Meeting Agenda **Skokie Appearance Commission** Wednesday, September 13, 2023 at 7:30 P.M. Village of Skokie 5127 Oakton Street Skokie, IL 60077

MEMORANDUM **Community Development Department**

APPEARANCE COMMISSION STAFF REPORT SUBJECT:

REMODELING & GARAGE ADDITION SINGLE FAMILY RESIDENCE 9248 KARLOV AVE SKOKIE, IL

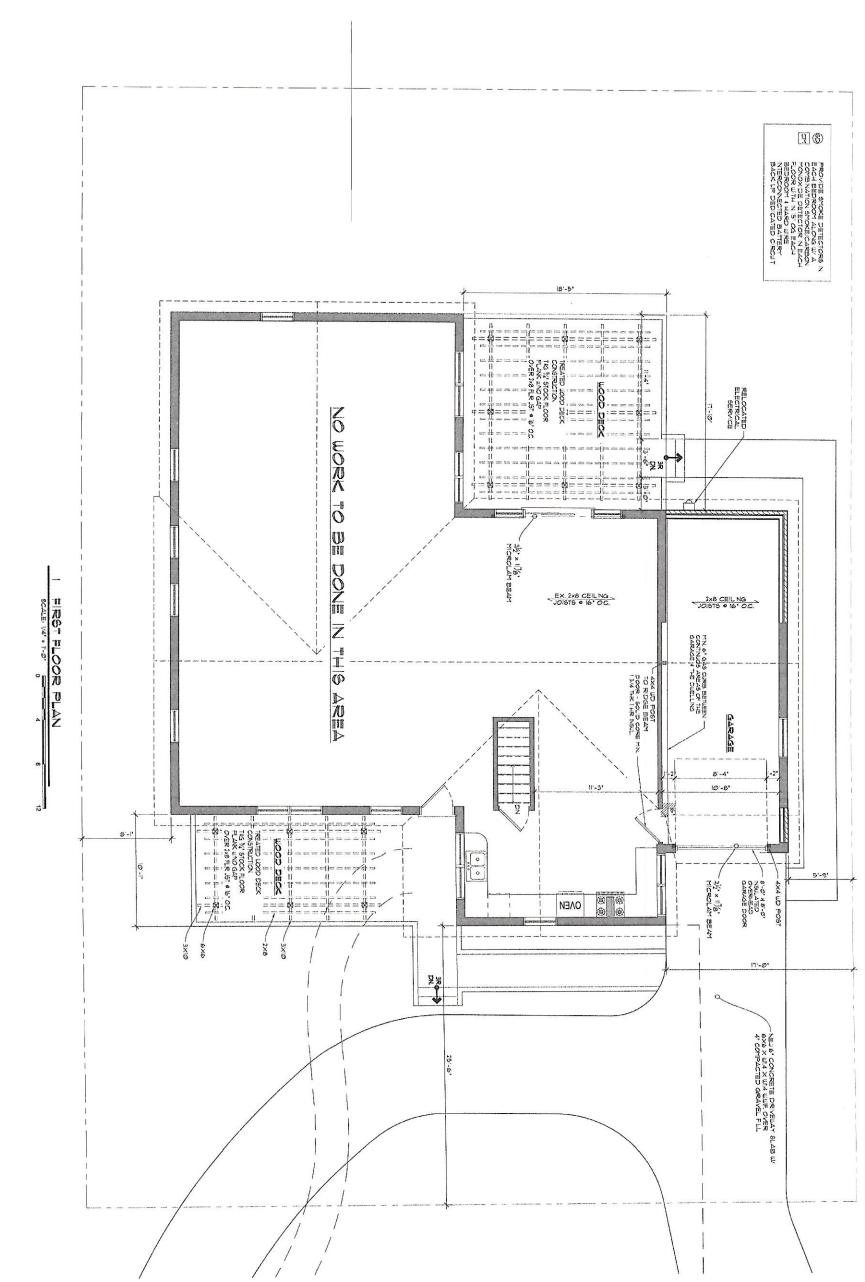
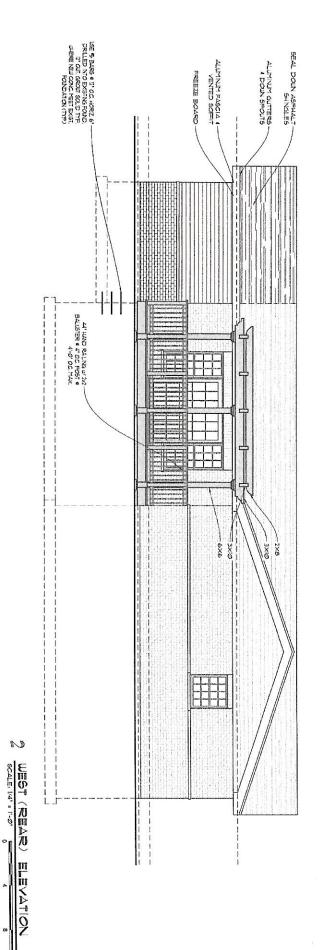
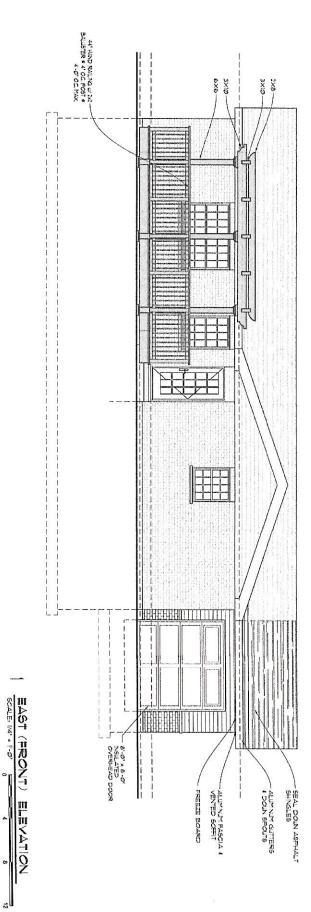
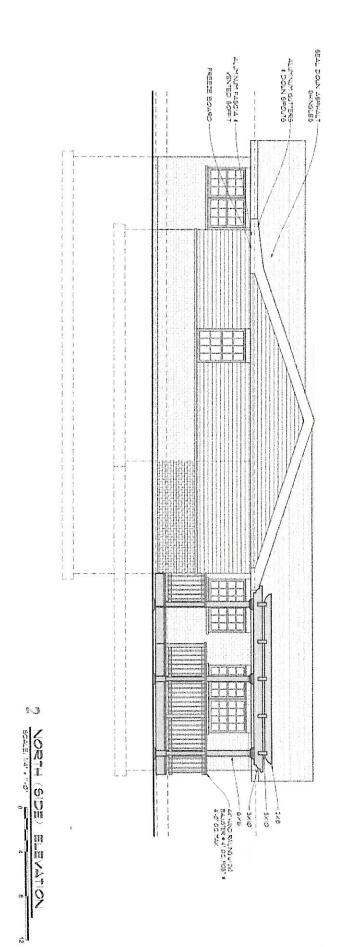
- 2023-031A 9248 Karlov Ave – The applicant is proposing to convert a room to an attached garage, construct a covered porch behind the garage and change the roof over the converted room. Staff has no objections to the proposed elevation changes. The proposed roof nicely matches the existing. The materials appear to match existing, if they do not they should complement the existing siding and brick.
- 2023-033A 9100 Kenton Ave – The proposed addition and remodeling will require a fire sprinkler system through the entire residence.

Overall staff is not supportive of the proposed elevations. The façade does not meet the 50% minimum masonry as required by the Skokie Village Code. The bay window and guard rail appear out of place on the east elevation. The west elevation needs could use a window. Staff would prefer masonry on the 1st floor west elevation where there is siding.

The proposed covered porch is not permitted in the required front yard or corner side yard. As proposed the porch appears to be in both required yards. If the porch is removed it may dramatically alter the elevations that face both streets.

Staff recommends the petitioner change the plans and appear at a future hearing.

PROPOSED SOUTH ELEVATION

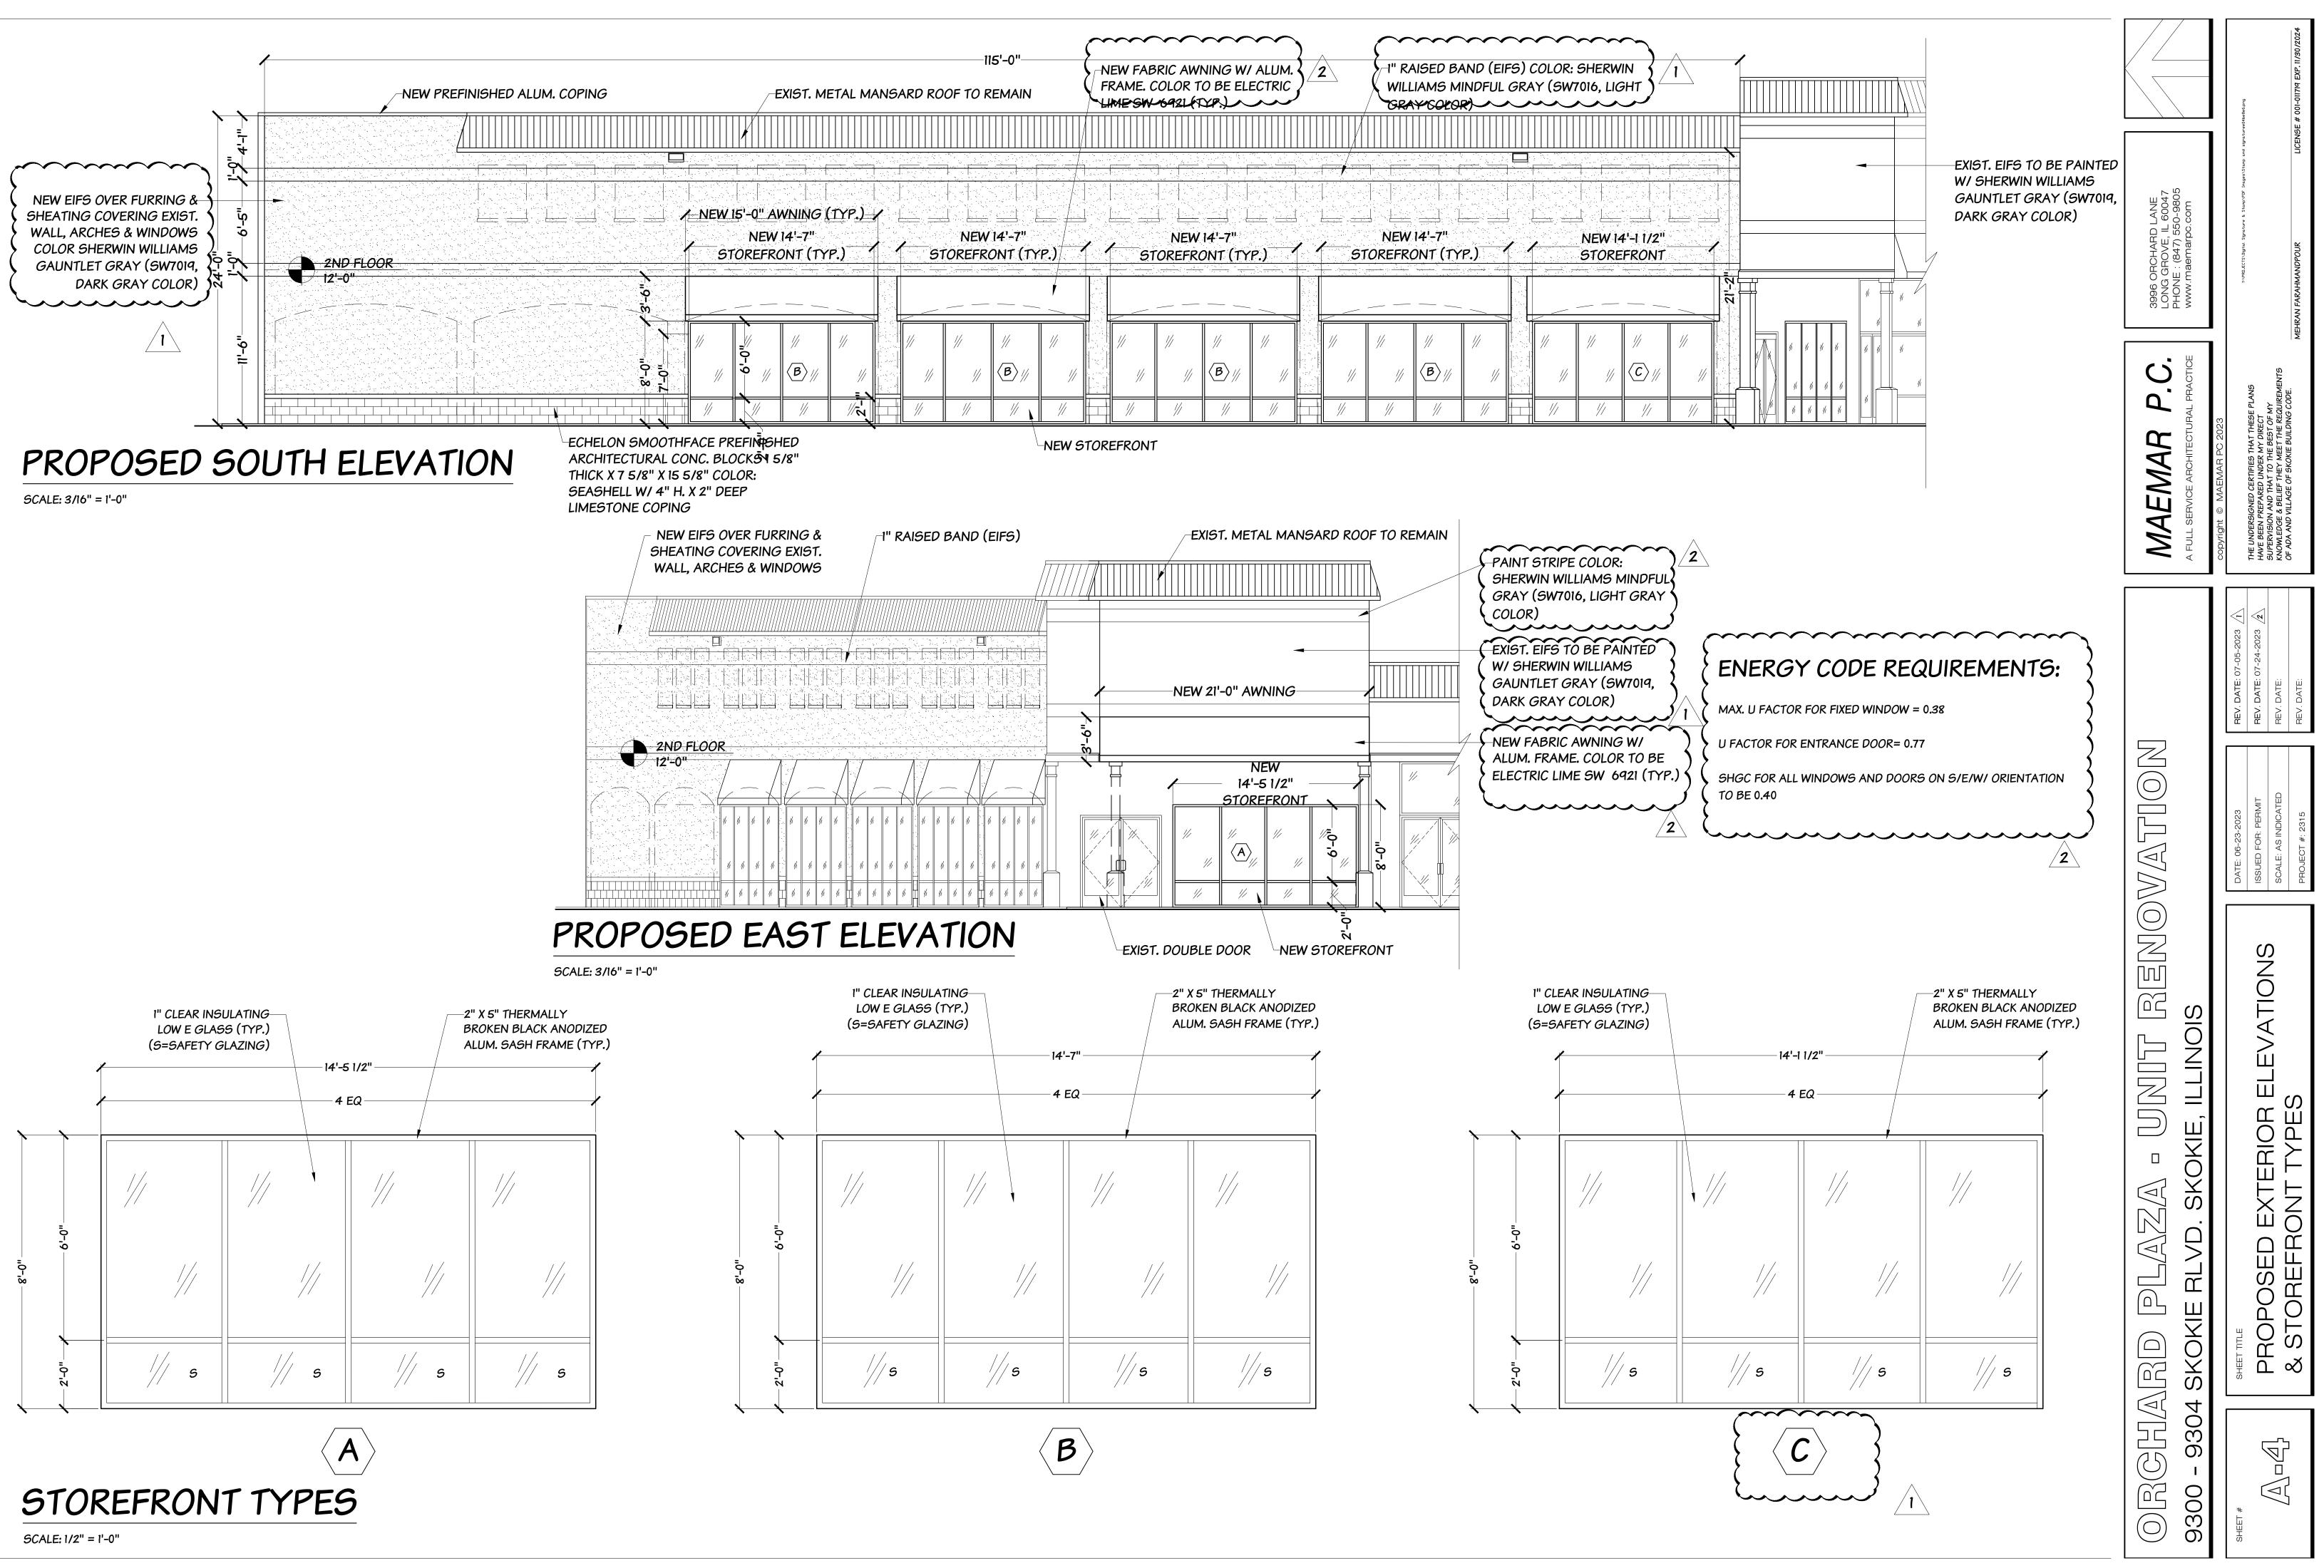
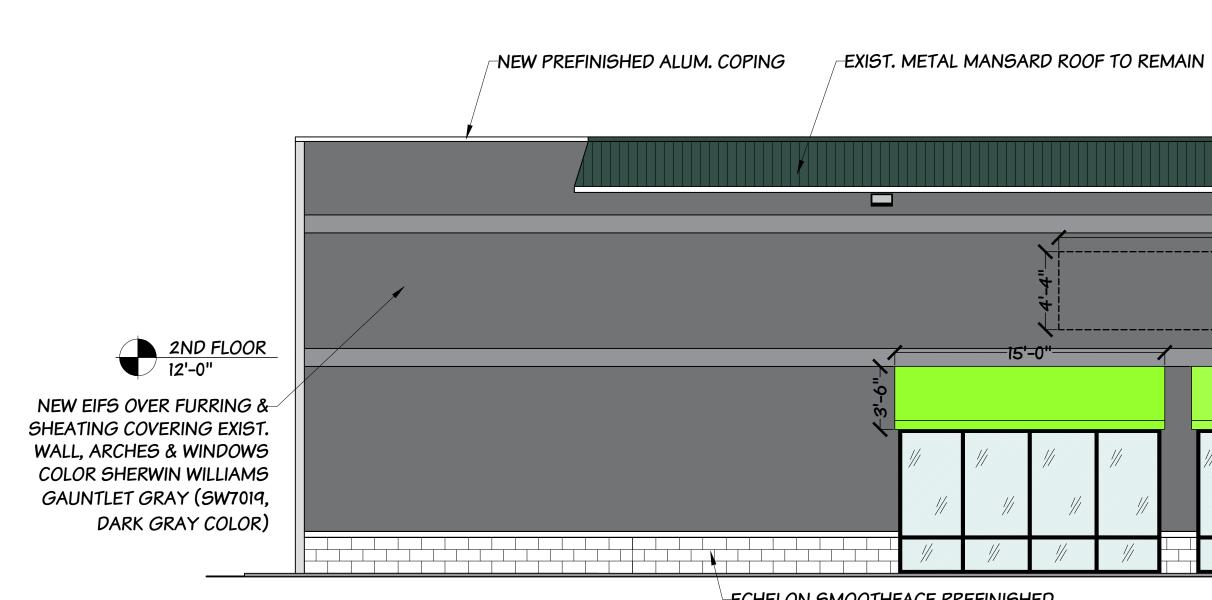
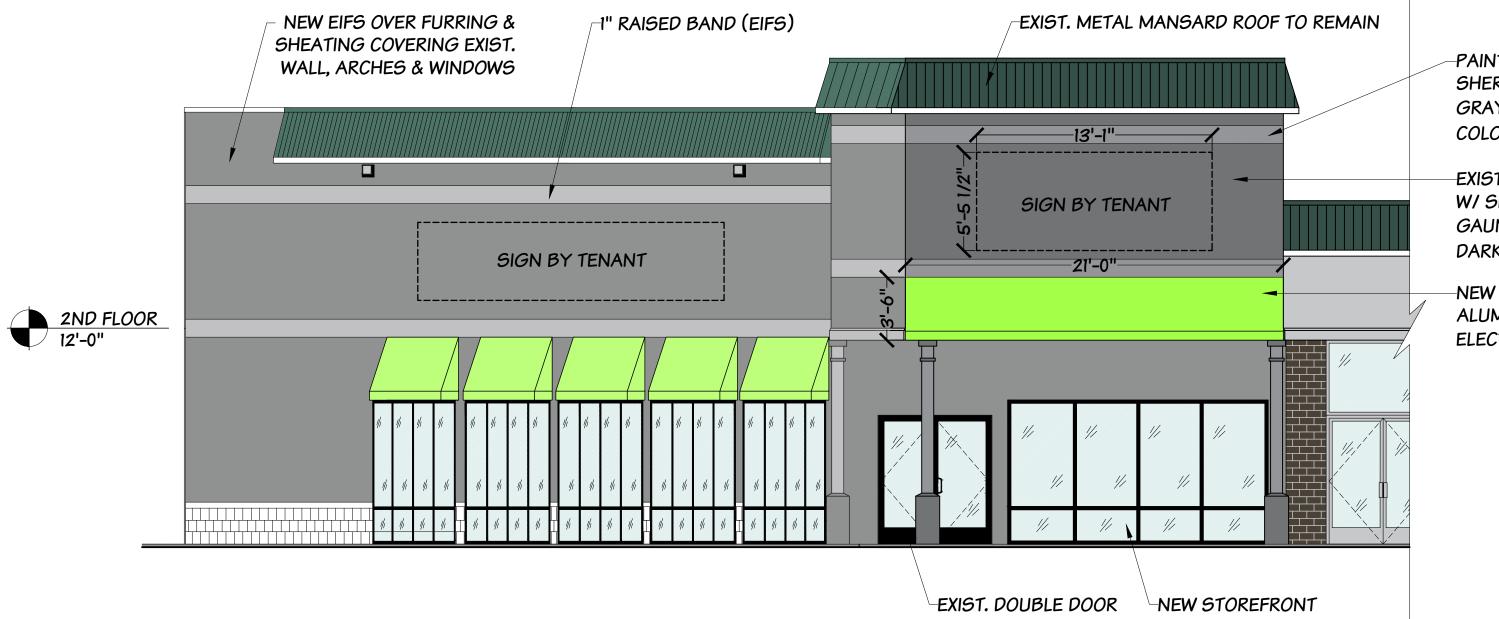
- **2023-030A 10001 Skokie Blvd** Staff has no objections to the proposed elevation changes. The proposed fiber cement panels behind the sign are complimentary to the columns and new wall and parapet colors.
- **2023-028A 9300 Skokie Blvd** Overall staff has no objections to the proposed elevation changes. The proposed new gray facade doesn't appear to clash with the lighter color façade that exists on the adjacent facades (Emma's Bagels etc.).
